CERTIFICATE OF APPROPRIATENESS

**RE: Application Number 20-6984; 439 Henry; Cass-Henry Historic District
Project Scope: Rehabilitate Apartment Building**

RE: 439 Henry Street—Bretton Hall

Sheet
4A401

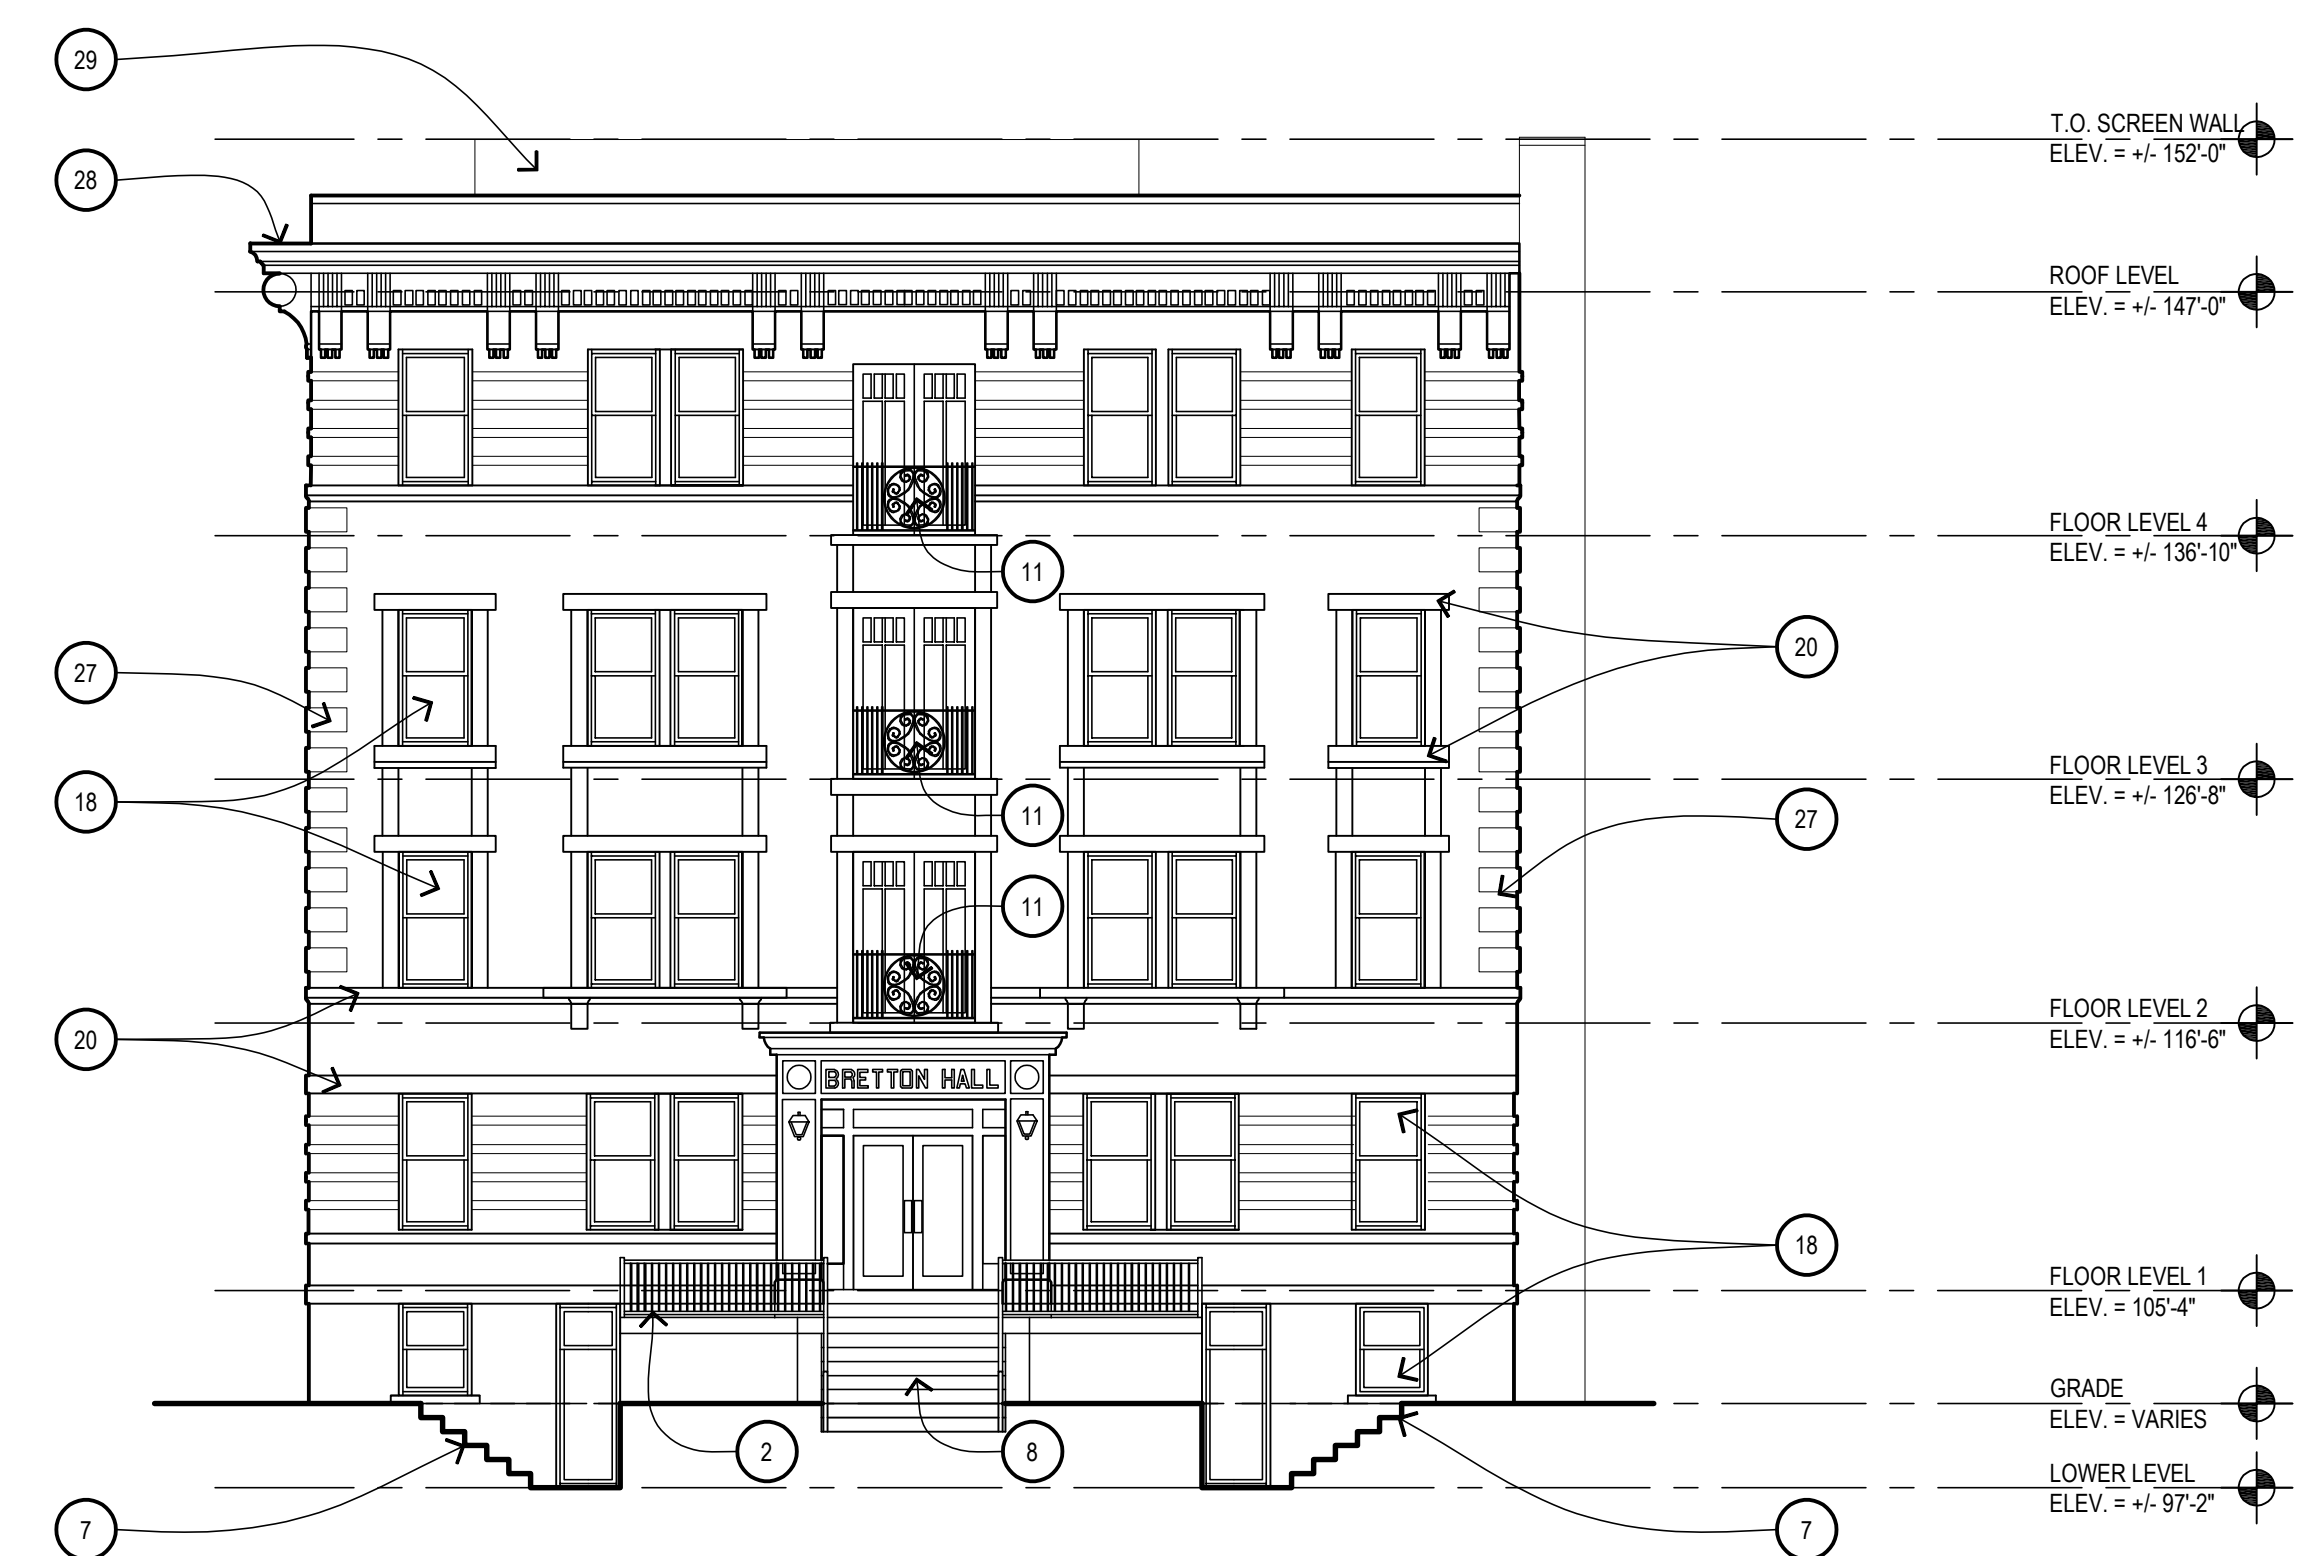
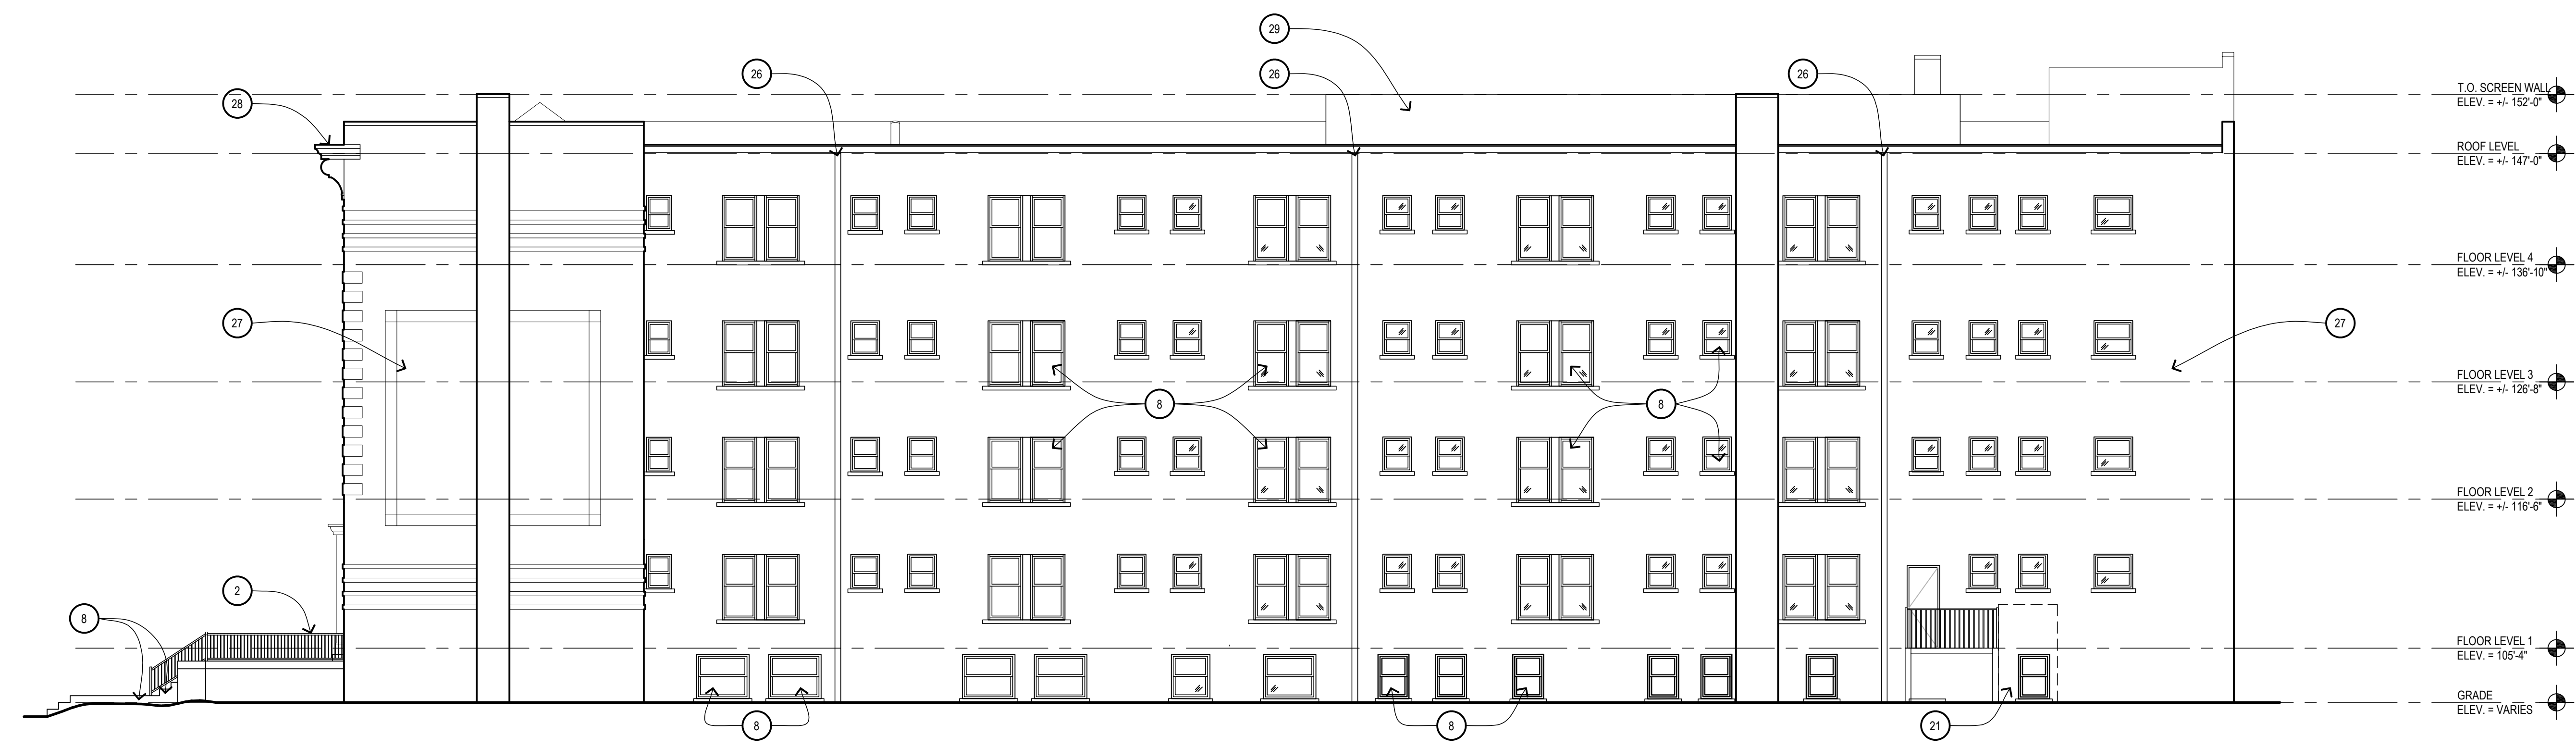
- *Main entrance door will be replaced with a new door to match the existing historic door, with new hardware*
- *Basement doors will be replaced with new doors to match the appearance of the eastern door (without the chute)*
- *Balconette doors at north façade will be inspected for damage/condition and repaired as necessary. Doors found to be deteriorated beyond repair will be installed which match the existing. Aluminum*

And, as per the submitted documents, specifically drawings 4A101, 4A102 (floor/roof plans) and 4A401, 4A401.1, 4A402, 4A402.1 (elevations)

Sheet
4A402

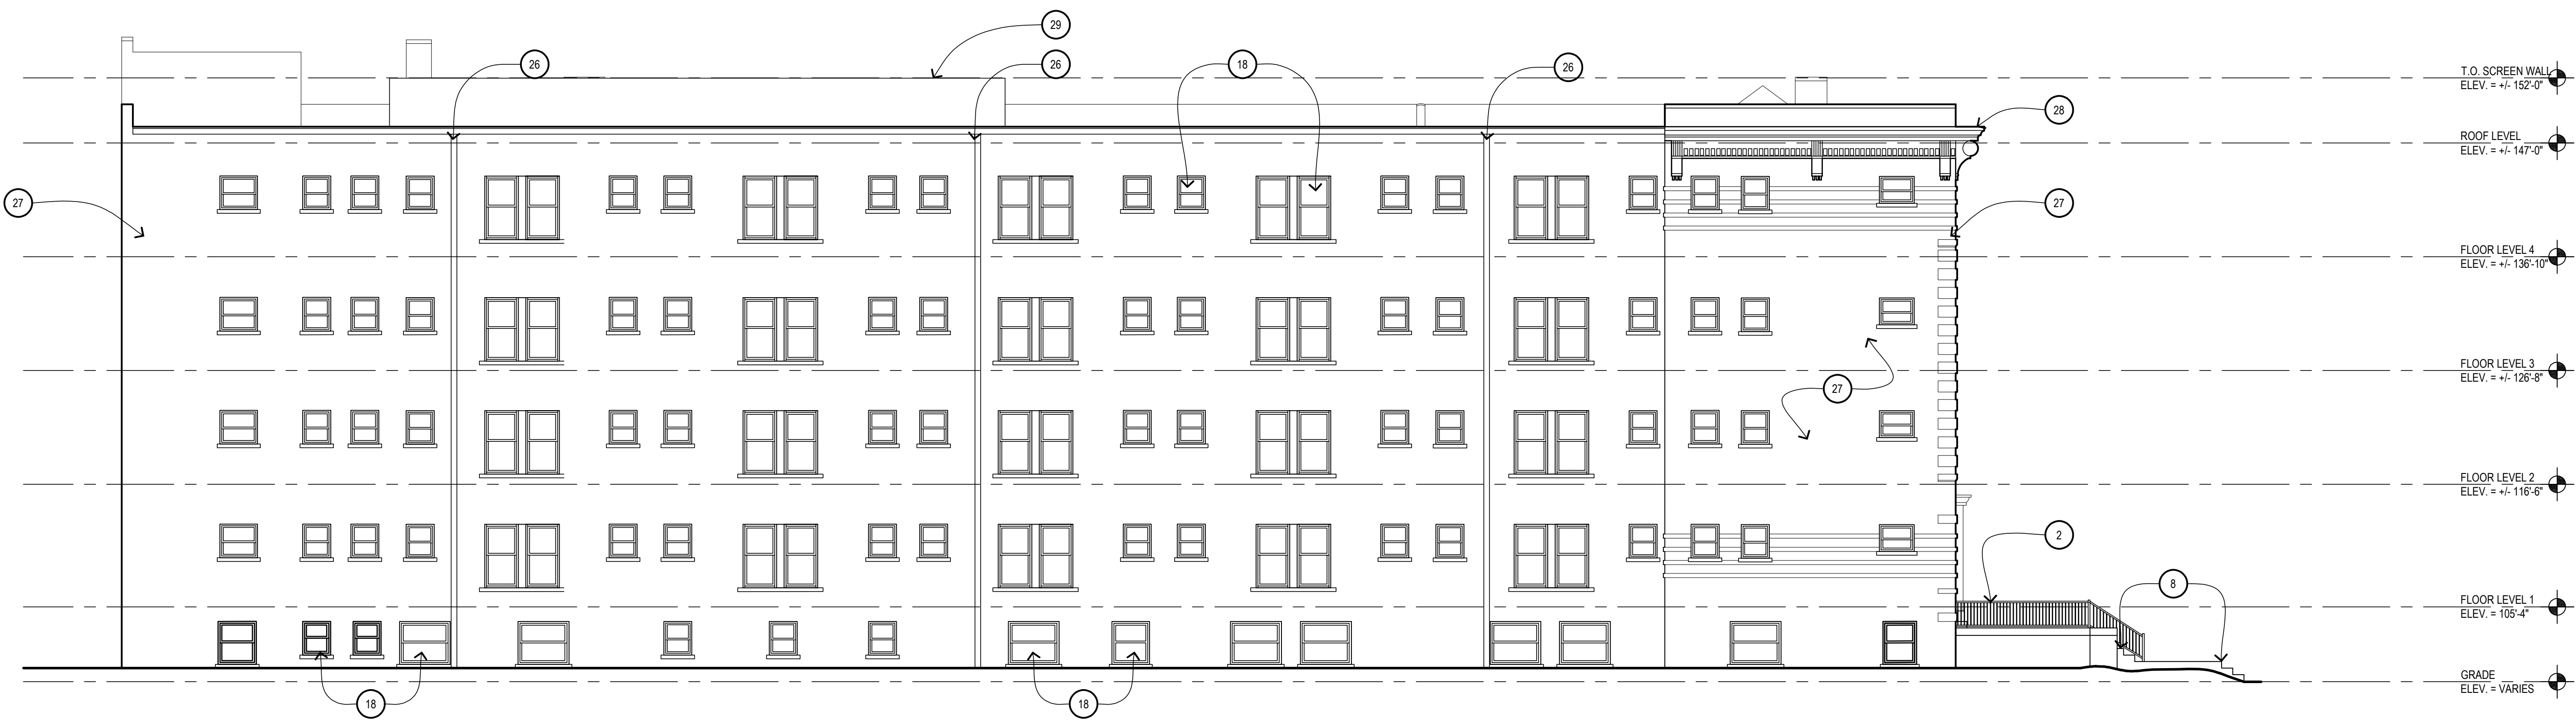
- *At the rear elevation, the ground floor steel door and the furniture loading doors will be inspected for damage and repaired as necessary. The metal guardrails at the furniture loading doors will be replaced with a new metal guardrail system.*
- *Per drawing 4A401, an ADA lift and new entrance door will be installed towards the rear of the building at the west elevation*
